14 CFR
PART 150
UPDATE

Public Hearing/Comment Period Appendix Note: This appendix includes presentations and information provided for the San Diego International Airport Part 150 Study public hearing and public comment period. Contents include the public hearing presentation, advertisements for the meeting, and the responses to the public’s comments.

SAN DIEGO INTERNATIONAL AIRPORT TITLE 14 CODE OF FEDERAL REGULATION PART 150 STUDY UPDATE RESPONSE TO COMMENTS MATRIX

Existing NEM (2018)

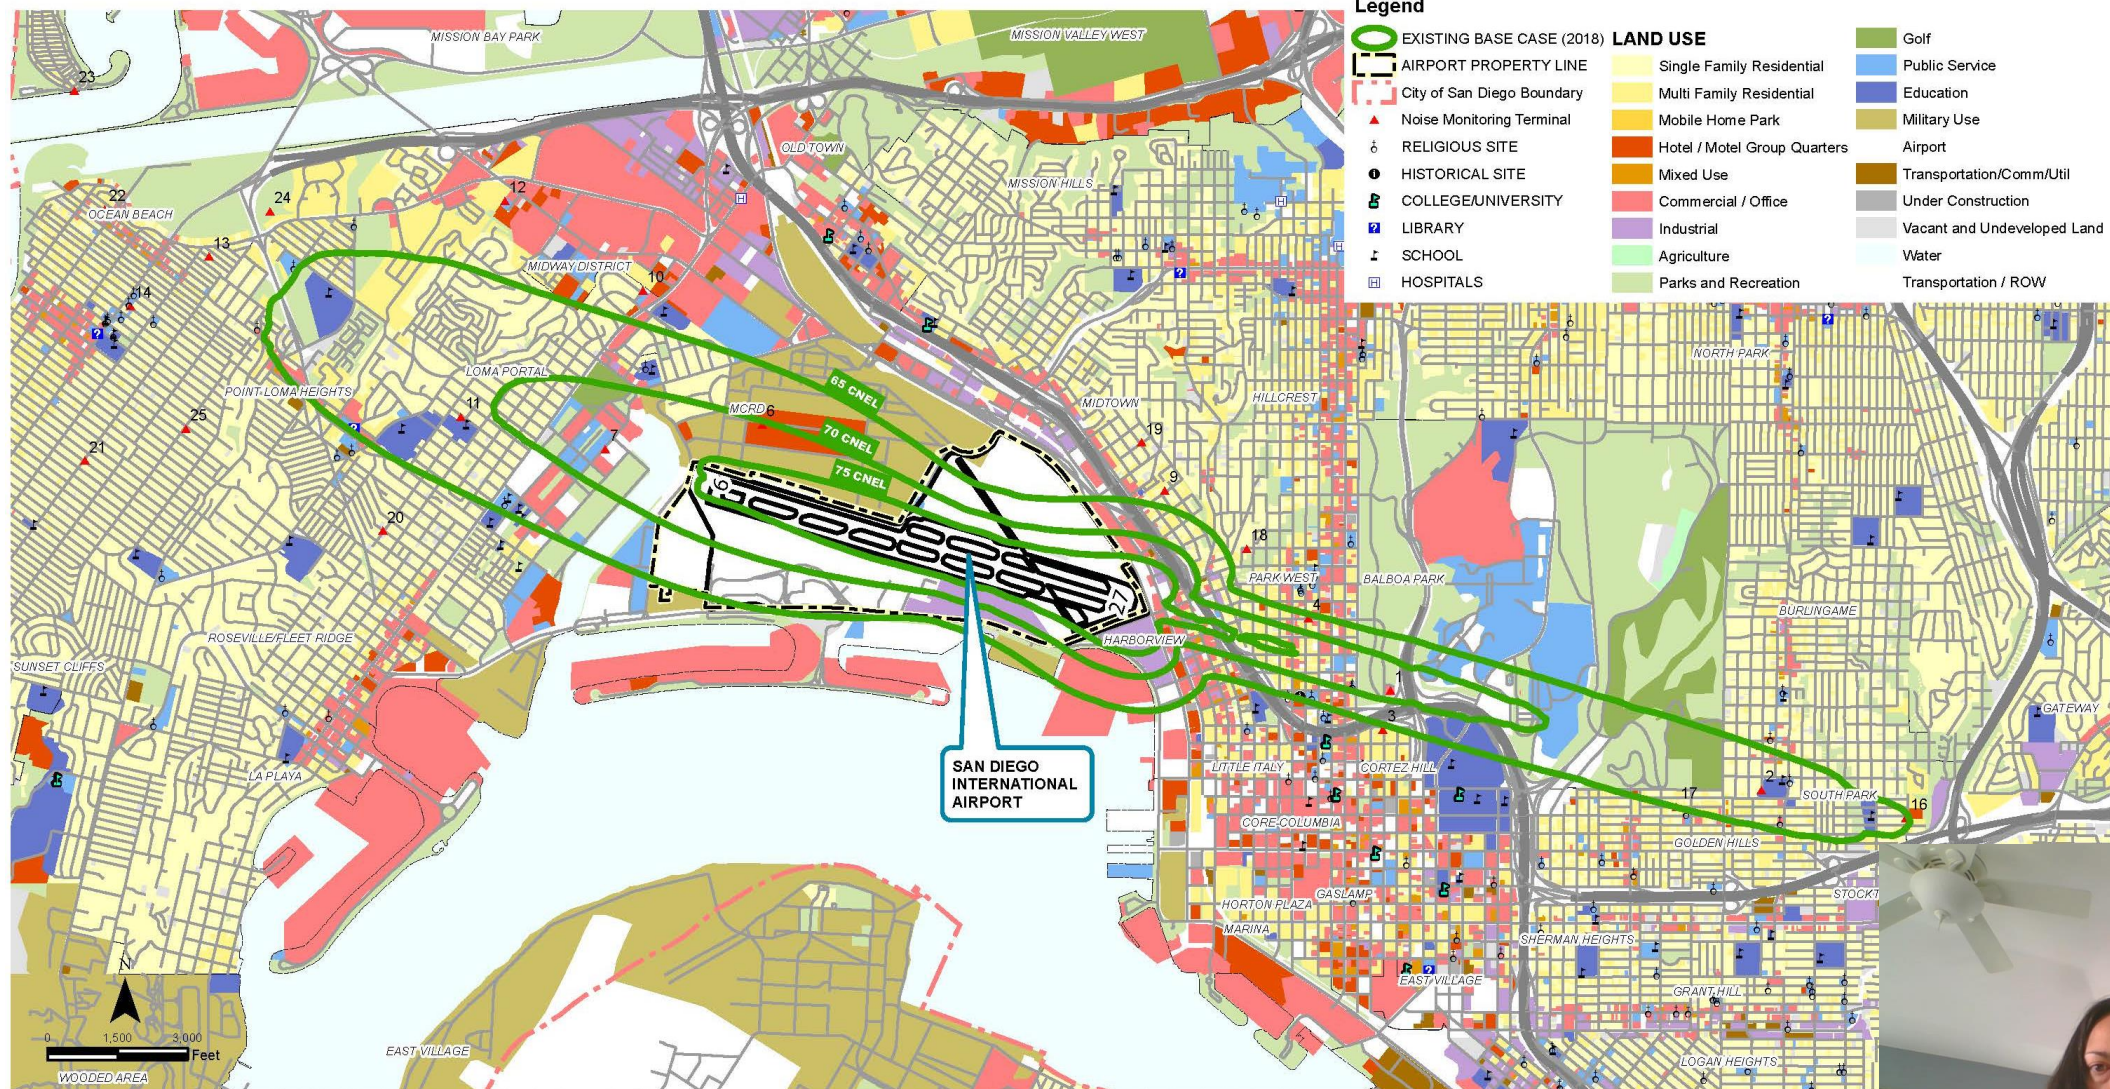
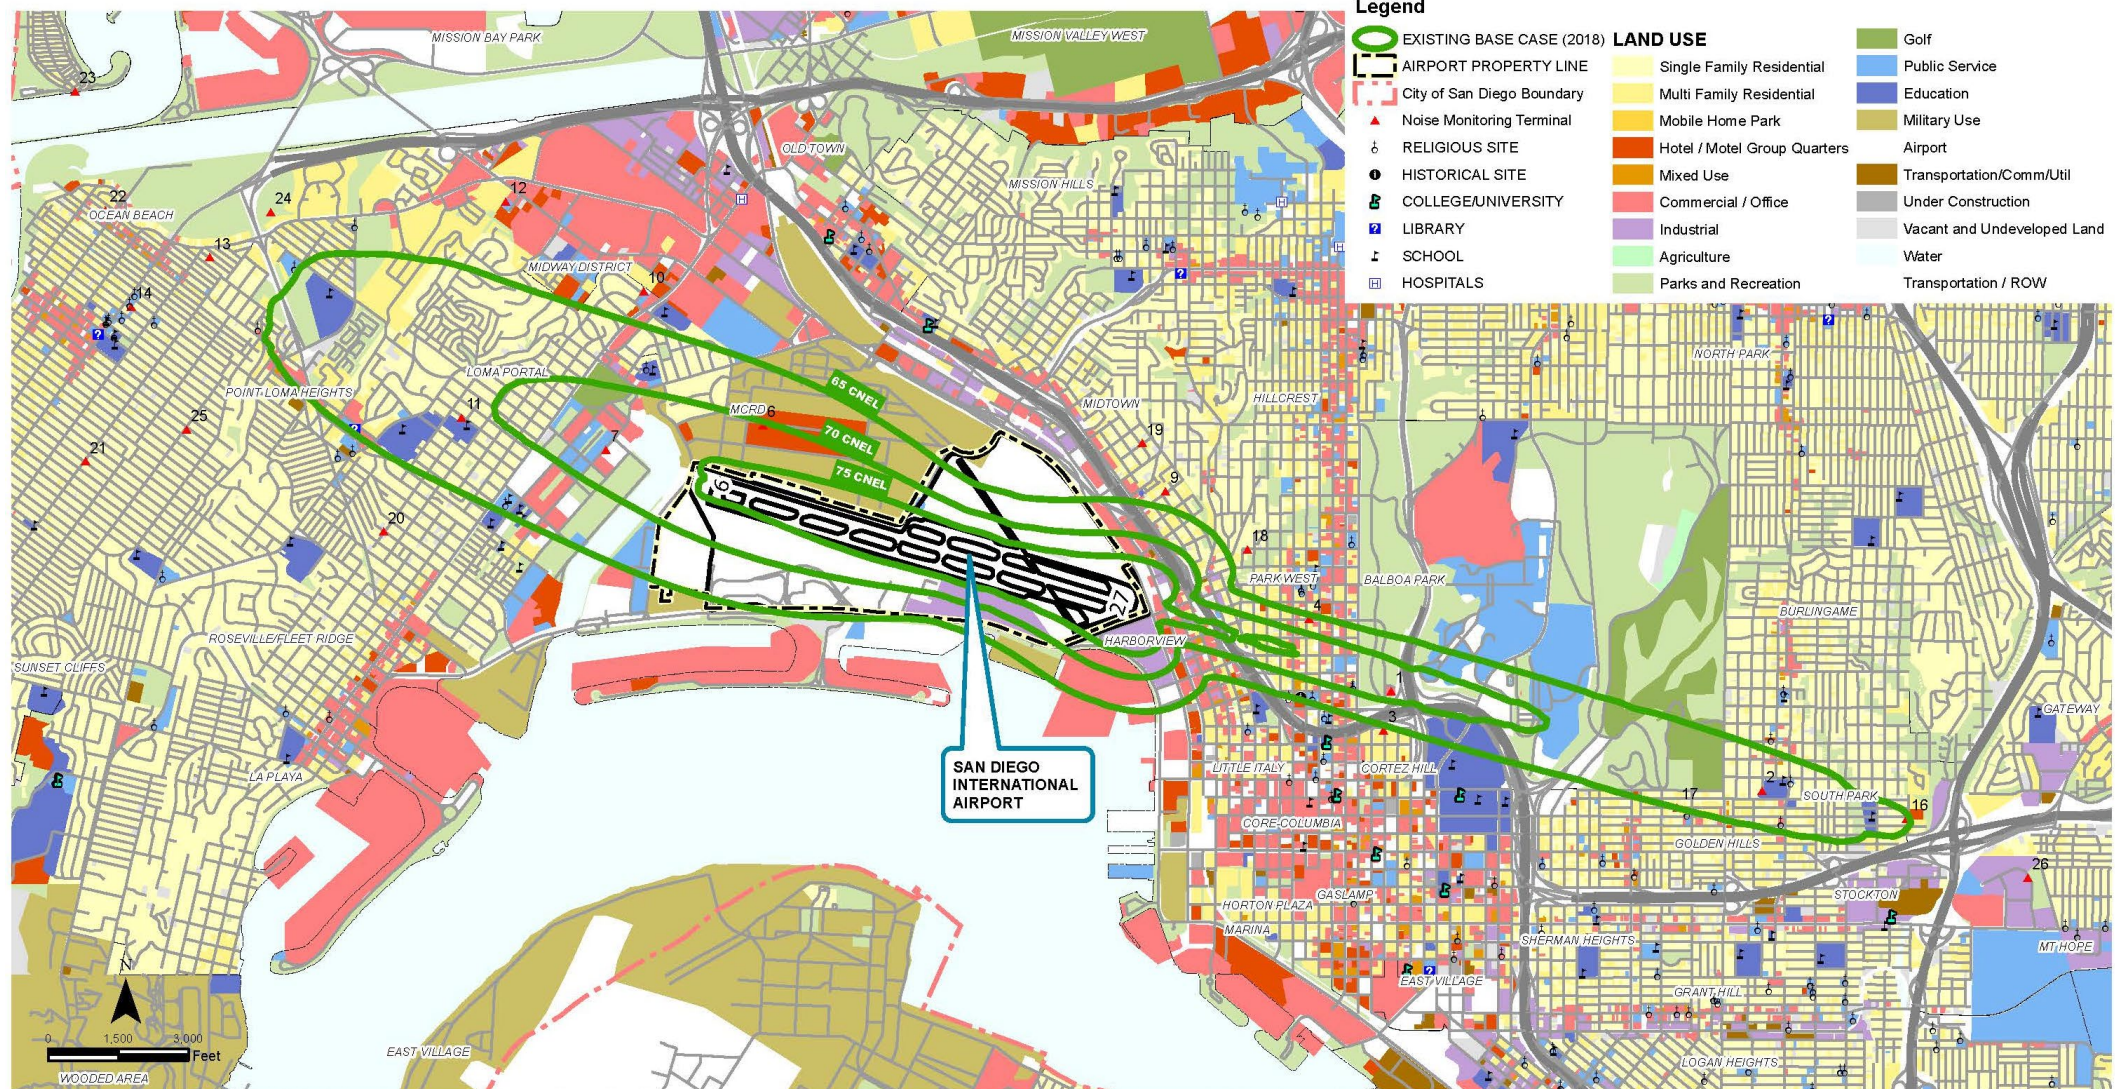
7 I'm here today to speak mostly about the
8 large narrow body of fleet projections. There's major
9 miscalculations on these. There are no 737 900s
10 listed. There are no Airbus NEO airplanes listed on
11 any -- on either the 2018 or 2026. 2026, there's only
12 two Maxes, two roundtrip Maxes. So obviously the west
13 side contours have got to be way off to some extent.

14 Old technologies aircraft, the current
15 ones -- I'm excluding the Maxes and the NEOs -- are
16 expected to go up by 32 percent, from my calculations,
17 from the 2018 numbers. I'm not sure where those
18 airplanes are coming from since they're out of
19 production, and a lot of them are being retired at this
20 point.

21 The 320, for example, is being doubled in the
22 expectations, and the airplane will be 27 years old in
23 2026. Southwest is buying 737 700s, Maxes, to retire
24 their 737 700s, but you're expecting 80 percent more of
25 them any ways.

Airport Authority assumptions found inaccurate!
(Noise analysis is complex; geometry is not)

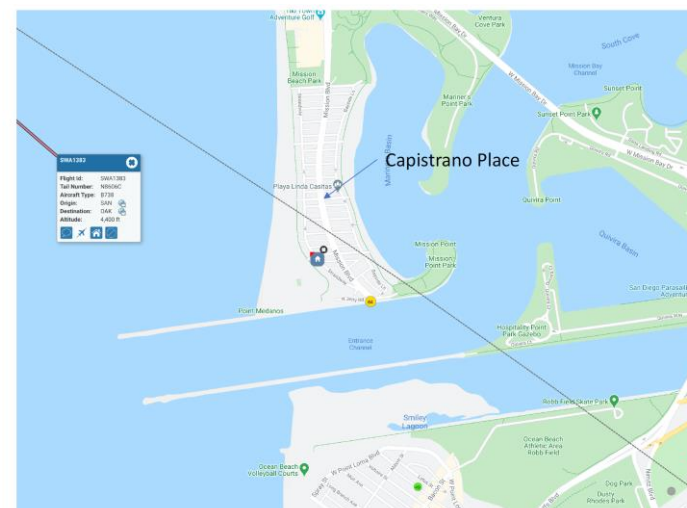
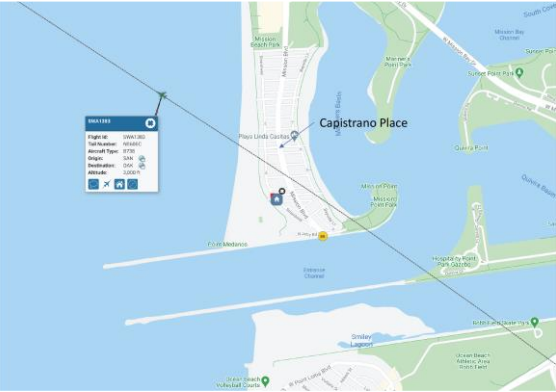
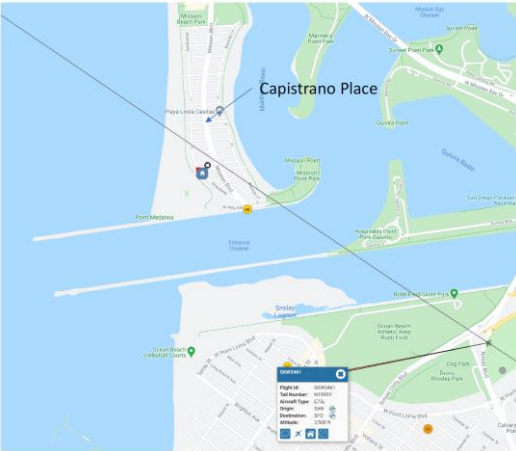
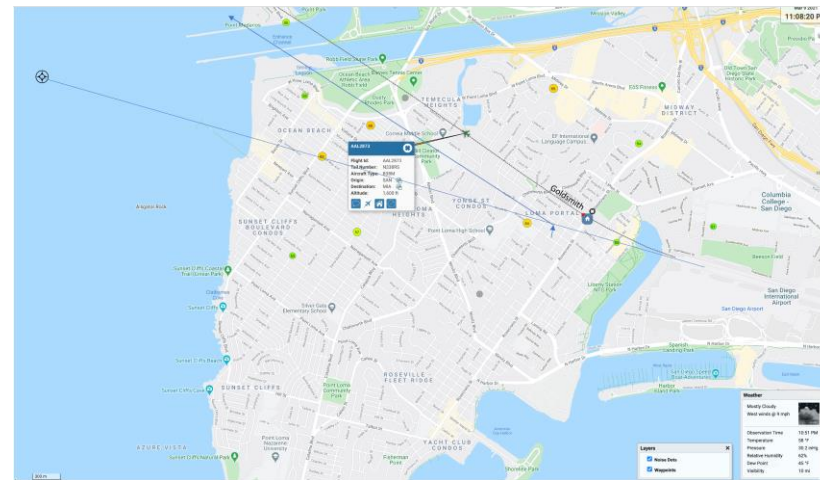
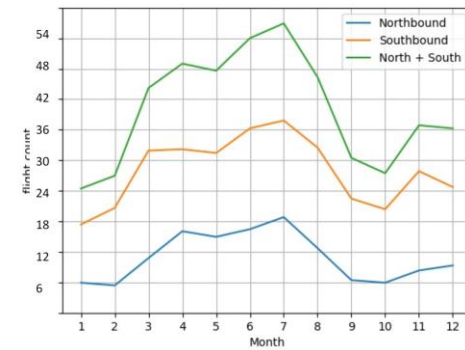
March 10, 2021	Gary Wonacott	Email to Consultant	290 Vector Departure	1	<p>I would hope to think that you were caught in the middle. It seems clear to me, and perhaps this was not revealed to you in the beginning, that the noise abatement office did their best to eliminate the post 10 pm departures on the 290 vector and move them to the PADRZ SID. Mike Tarlton and I both heard Steve state that PADRZ would be used for the initial leg, for example for BROCK. And, it should have all stopped there, except for our Mission Beach representative who sat on her thumbs, even when Tarlton questioned the impact on Mission Beach.</p> <p>I was awakened last night by an AA departure on the 290 headed to Miami that was about as loud as is possible. Of course, the departure crossed over Mission Beach to my north. We will see, but I think in the long term, this has to change.</p>	<p>Section 7.2 of Chapter 7, <i>Operational Alternatives</i>, describes all of the operational alternatives evaluated in the Title 14 Code of Federal Regulations (CFR) Part 150 Study Draft Report. The alternatives were based on an evaluation of the San Diego International Airport (SDIA) Airport Noise Advisory Committee (ANAC) recommendations, comments received from members of the Technical Advisory Committee and Citizen Advisory Committees (TAC/CAC), and input provided by attendees at the first public workshop held November 21, 2019. Based on recommendations and comments received, 12 operational alternatives were evaluated. None of the operational alternatives evaluated for the 14 CFR Part 150 Study involved moving all departures between 10:00 p.m. and 6:30 a.m. to the PADRZ Area Navigation (RNAV) Standard Instrument Departure (SID) flight route.</p>

- Objective is to replace PADRZ with a departure south of the peninsula
- Small distances require accurate assumptions
- Airport Authority assumptions were grossly biased against Mission Beach and in favor of moving the post 10 pm 290 departures to PADRZ
- Calls from Mission Beach residents at least temporarily stopped the Airport Authority
- Data from Publics Records Request confirm inaccurate assumptions by the Airport Authority
- Need to keep pressure on Airport Authority to review their assumptions publically and to perform sensitivity studies to show effect of inaccurate assumptions

The commentor is referencing a proposed flight procedure developed under the Air Traffic Flight Procedure Evaluation effort for eastbound departures between 10:00 p.m. and 6:30 a.m. This proposed procedure would direct the aircraft on the same route as the PADRZ SID from Runway 27 to a waypoint over the ocean 1.5 nautical miles away from the shoreline, then turn left on an RNAV route heading to the ZZOOO waypoint. This proposed procedure was put on hold, per ANAC and TAC/CAC recommendation, until completion of the 14 CFR Part 150 Study operational alternative assessment.

As a result of the consultant's recommendations, the ANAC requested an assessment of potential impacts due to implementation of the proposed eastbound RNAV SID from the Air Traffic Flight Procedure Evaluation between 10:00 p.m. and 6:30 a.m. The noise modeling assessment indicated that if the eastbound departures are moved to follow the PADRZ RNAV SID path from Runway 27 to the shoreline, people and non-compatible land use would be newly exposed to levels at or higher than 65 CNEL. Based on the purpose of the 14 CFR Part 150 Study stated above, this change is not recommended by the consultants.

Please note that the commentor did not reference the attached graphics in the comment. The first and fourth graphics appear to address concerns related to the ground noise model track locations developed for the FAA's Aviation Environmental Design Tool (AEDT) noise model. Refer to Comment #4D below related to the ground noise model tracks developed for the 14 CFR Part 150 Study. The second, third and fourth graphic shows selected tracks for a unique flight, but no context as to the intent of each graphic. The sixth graphic shows the commentor's projections related to nighttime operations categorized by direction. The commentor did not indicate the intent of the information and the source and methodology used to derive the result. The last graphic appears to show an Area Navigation (RNAV) Standard Instrument Departure (SID) routes, but does not indicate if it is one of the alternatives evaluated in the 14 CFR Part 150 Study.
